STATE OF OHIO
 DEPARTMENT OF TRANSPORTATION
HAM US 42 10.07 READING RD
 HAMILTON, WARREN COUNTY
 CITY OF READING

REVIEW COMPLETE

IMPLEMENT TARGET SPEED PILOT PROGRAM COUNTERMEASURES ON US-42 IN THE CITY OF READING INCLUDING A ROAD DIET, ENHANCED CROSSWALKS, RRFBS, RAISED MEDIANS, IN AN EFFORT TO LOWER TRAVEL SPEEDS AND INCREASE VEHICULAR AND PEDESTRIAN SAFETY.

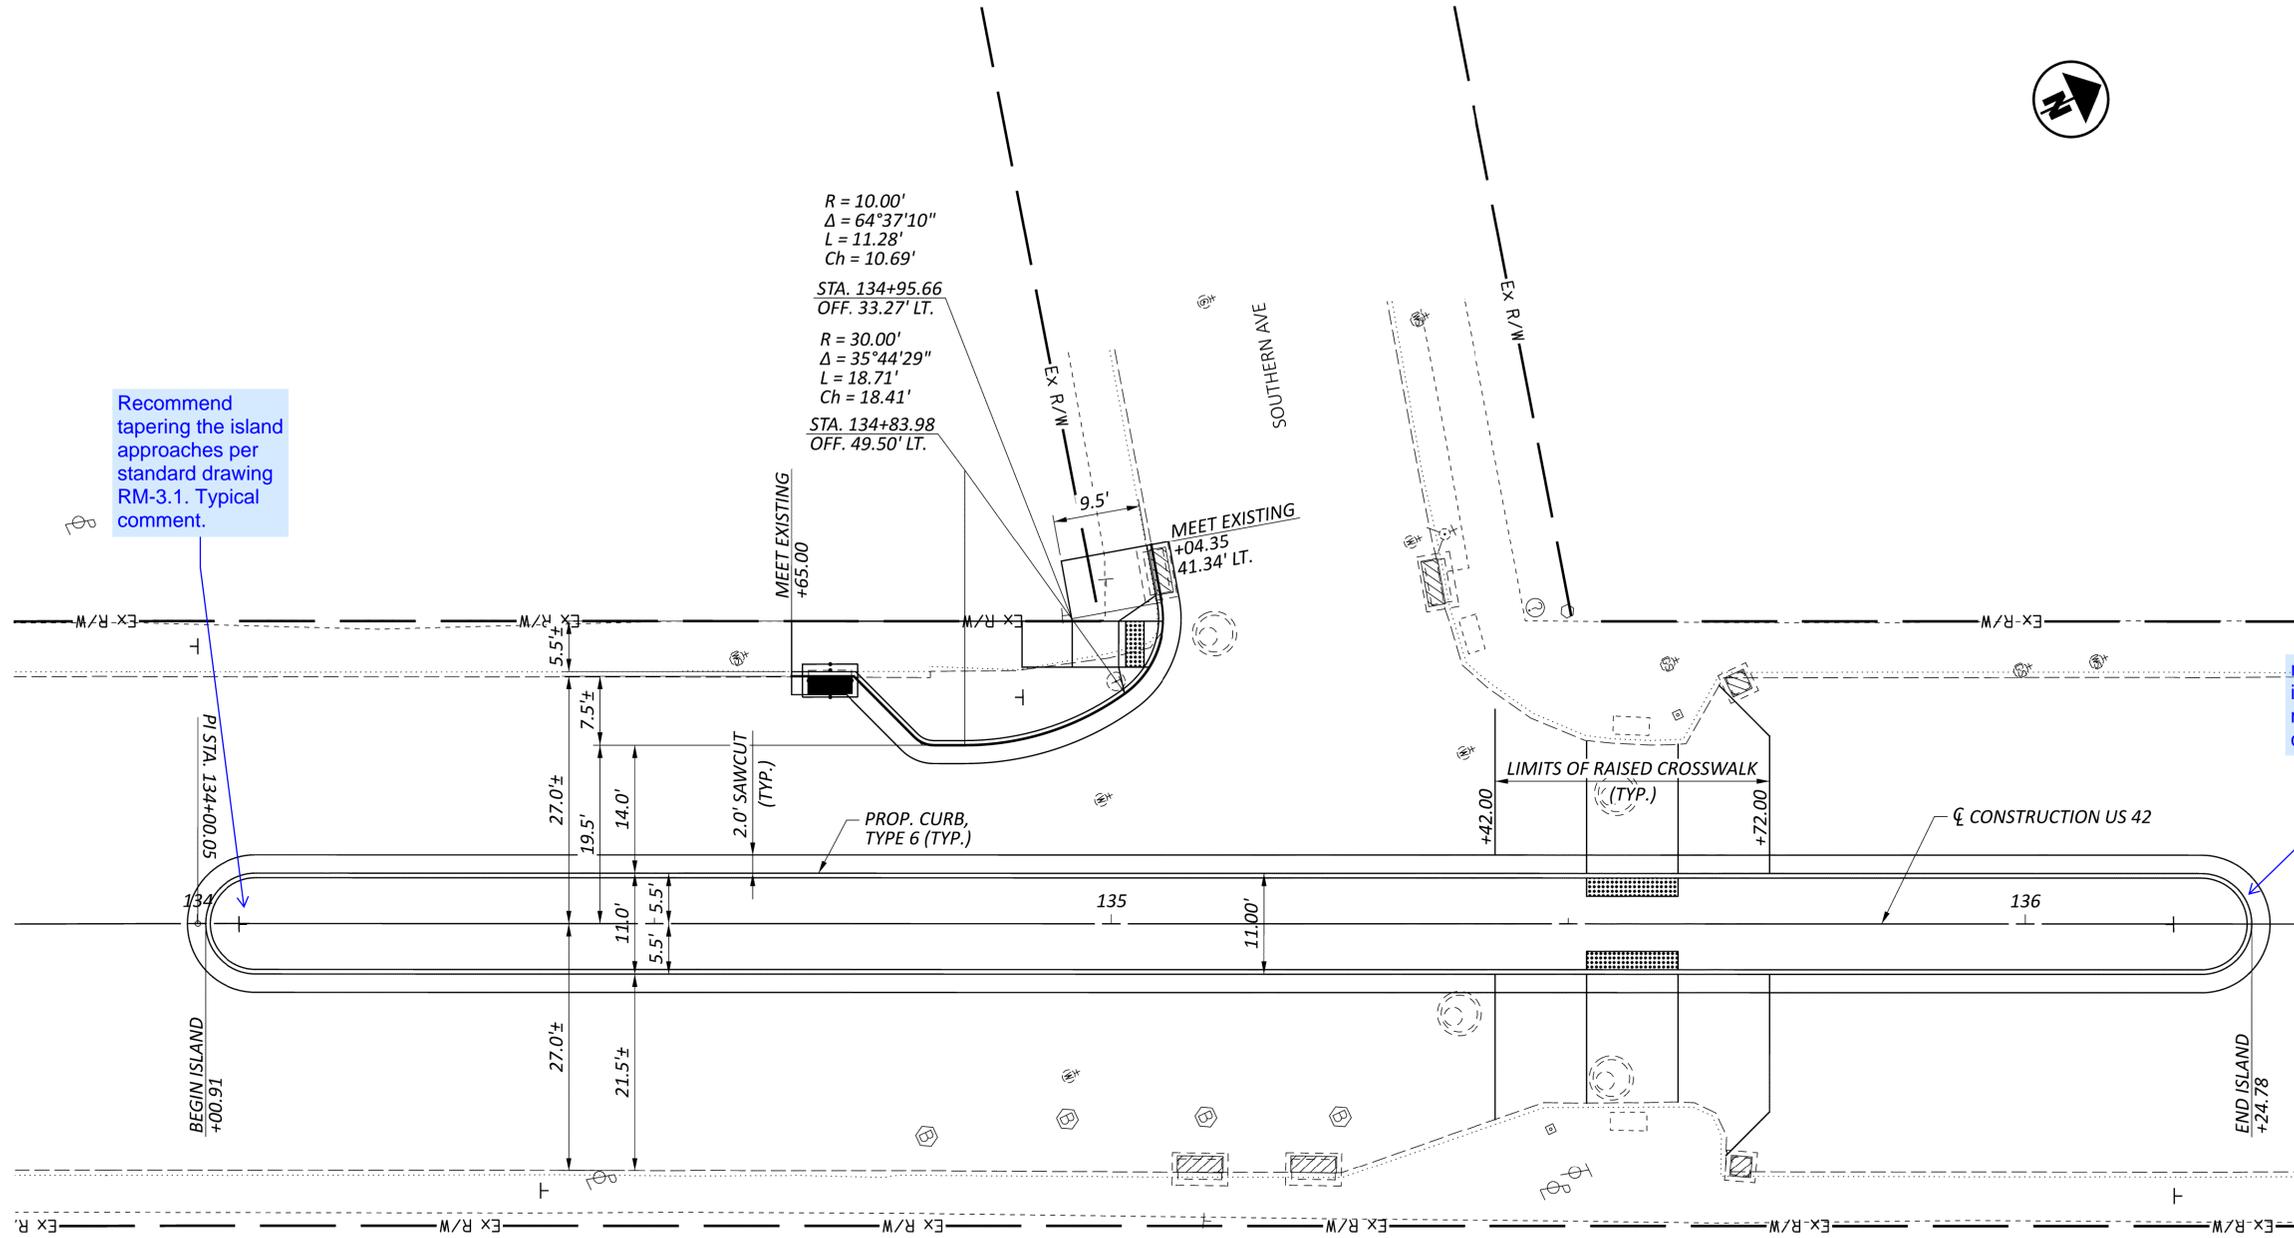
Recommend tapering the island approaches per standard drawing RM-3.1. Typical comment.

radius information missing. typical comment

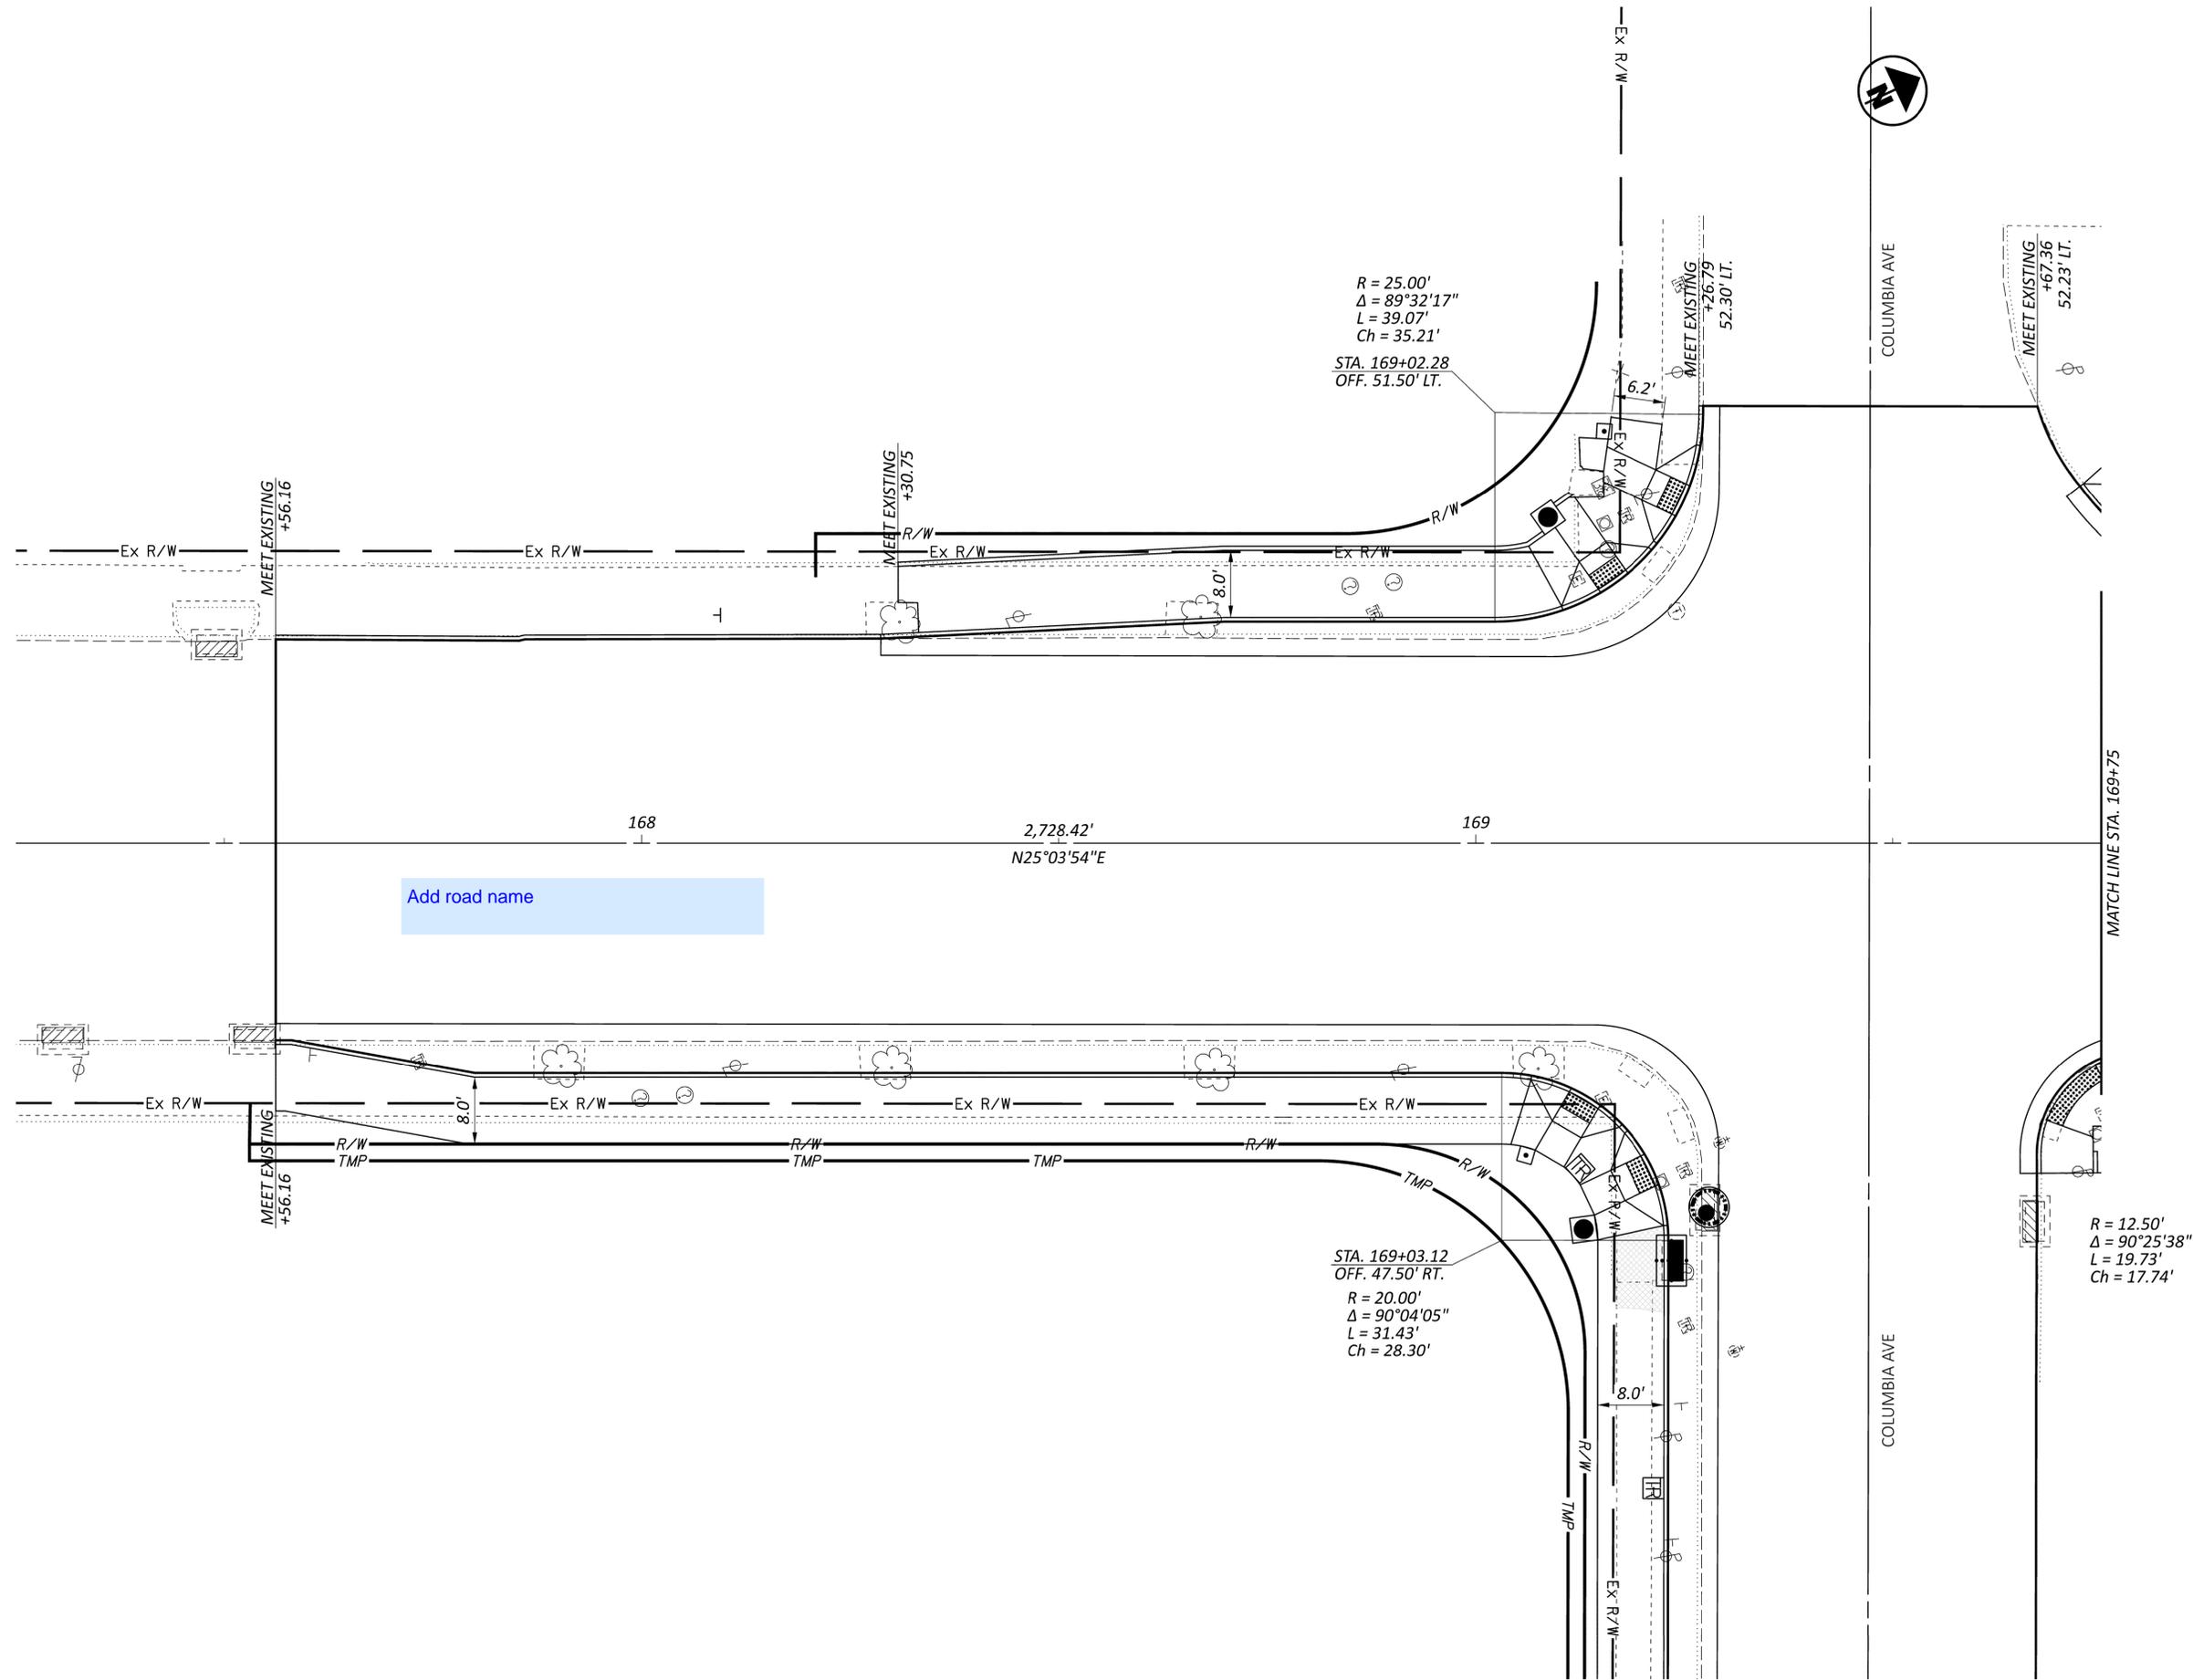
Add road name

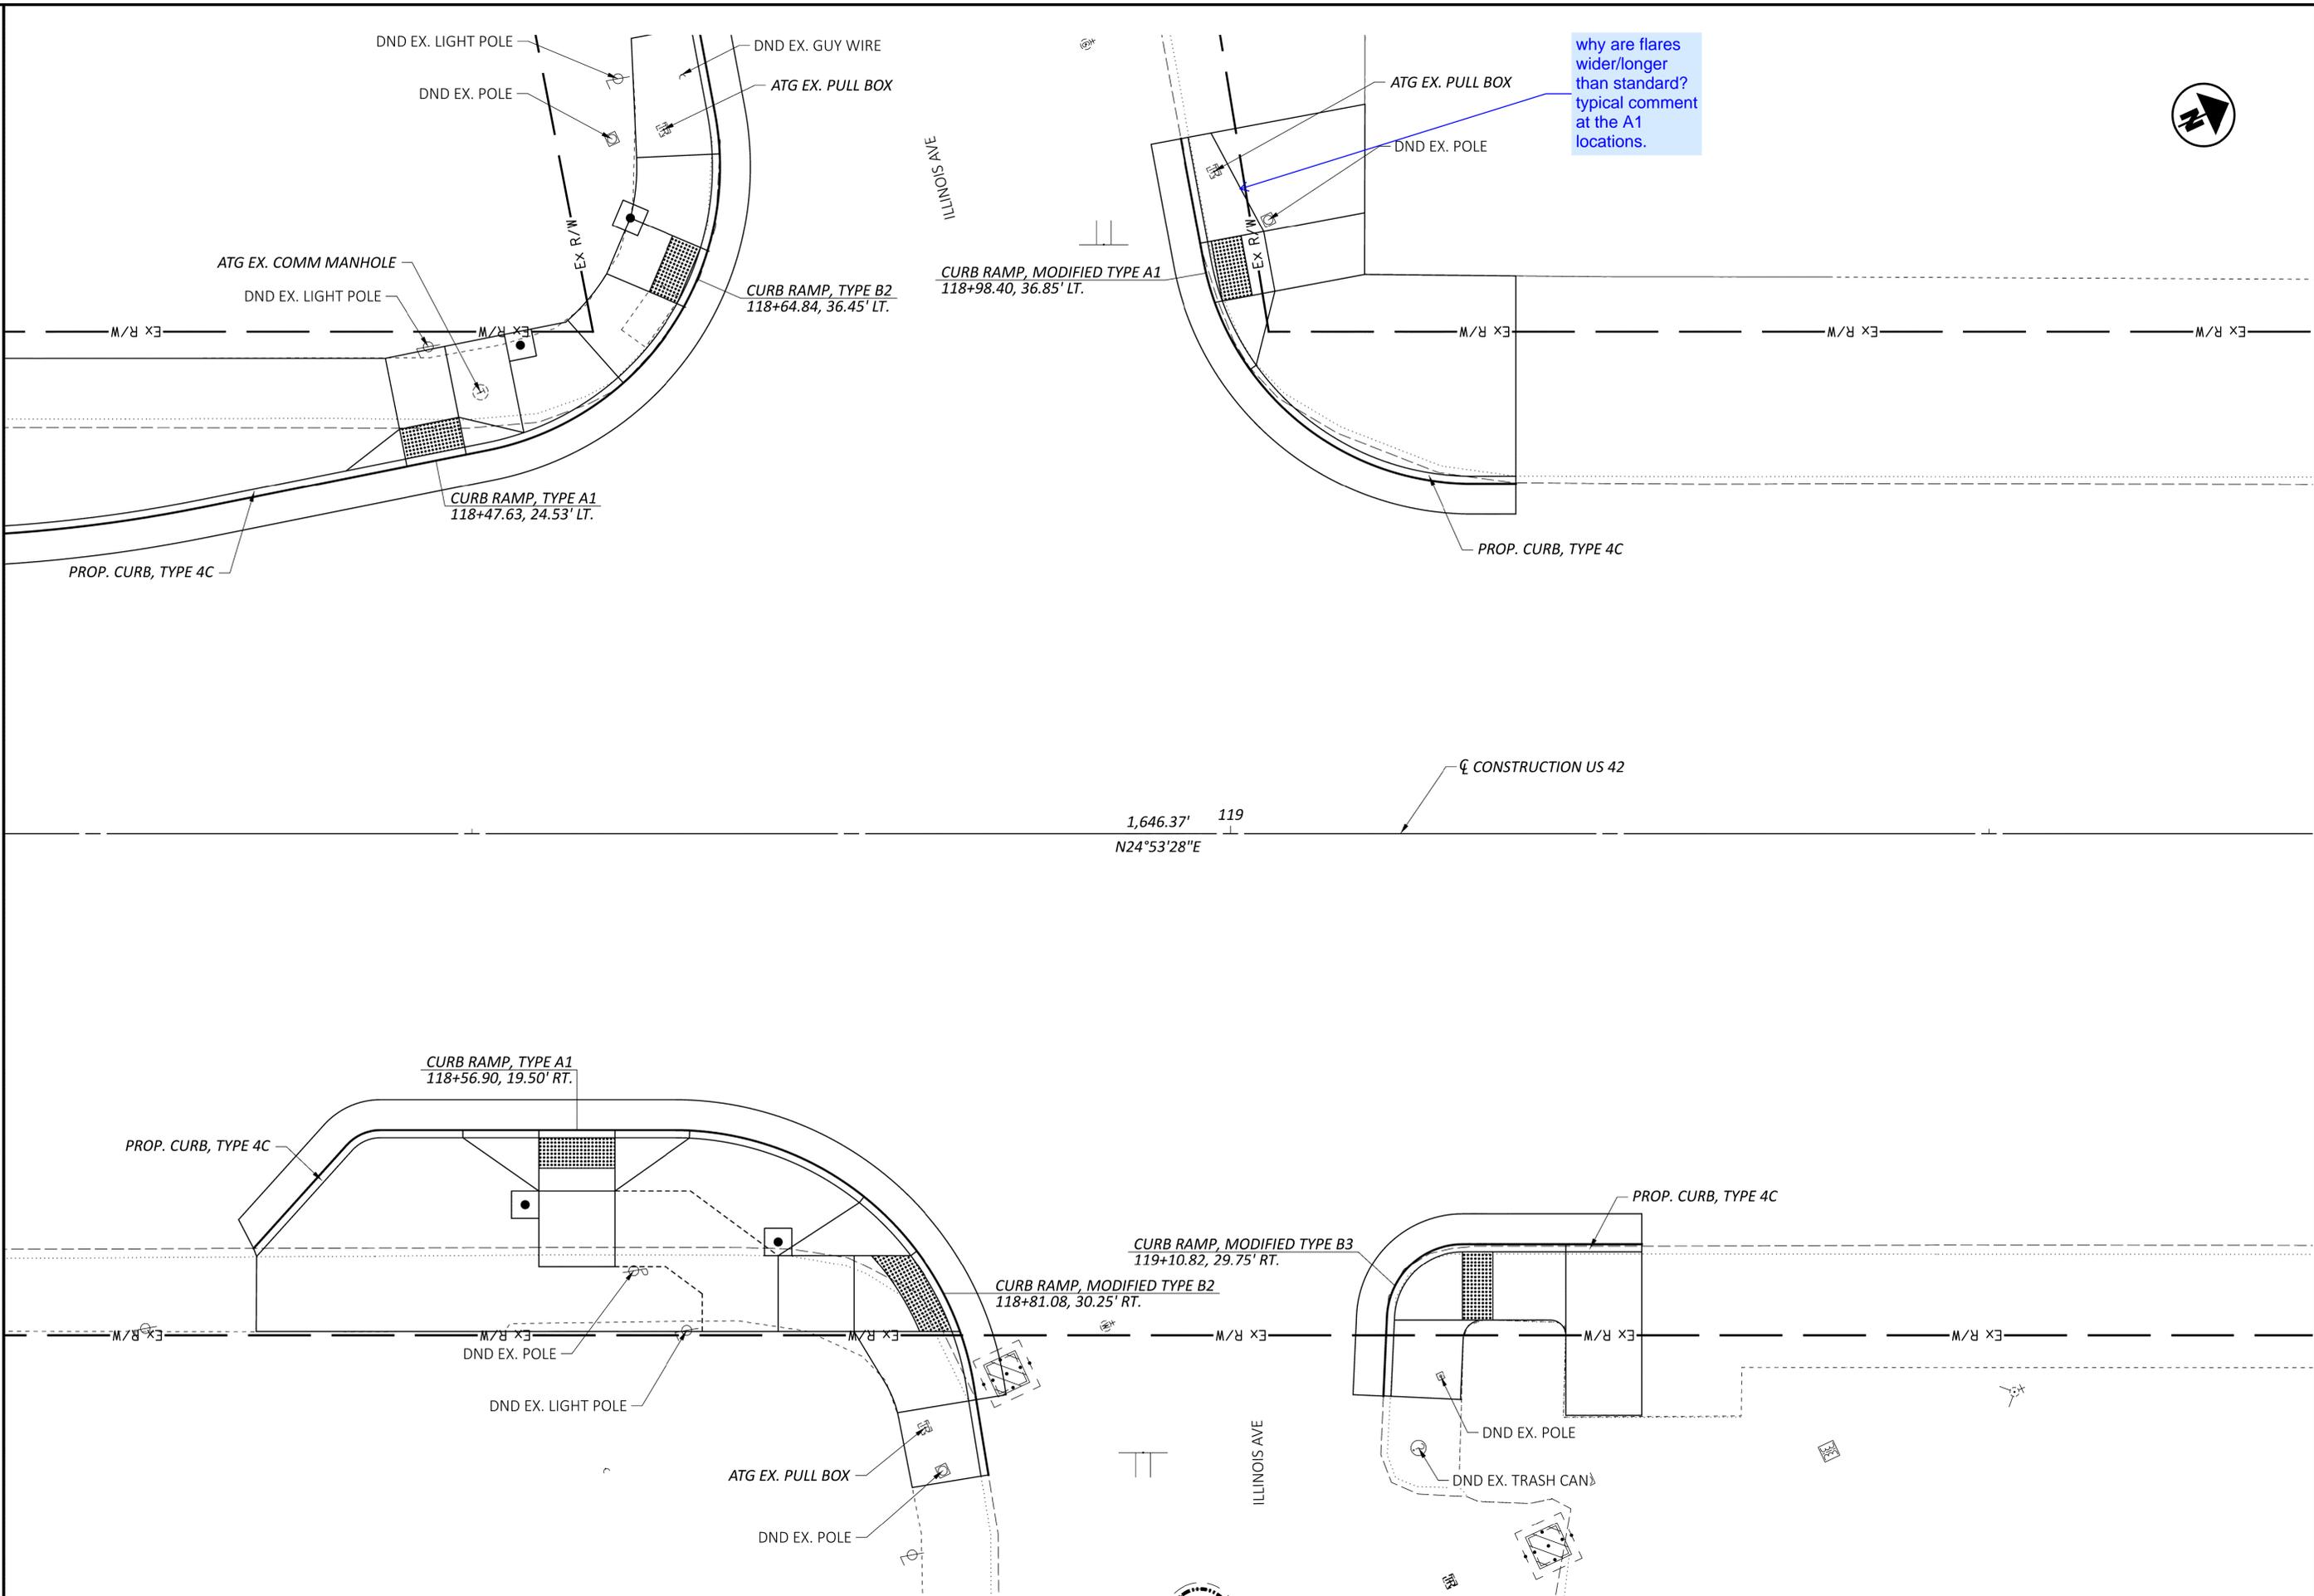
why are flares wider/longer than standard? typical comment at the A1 locations.
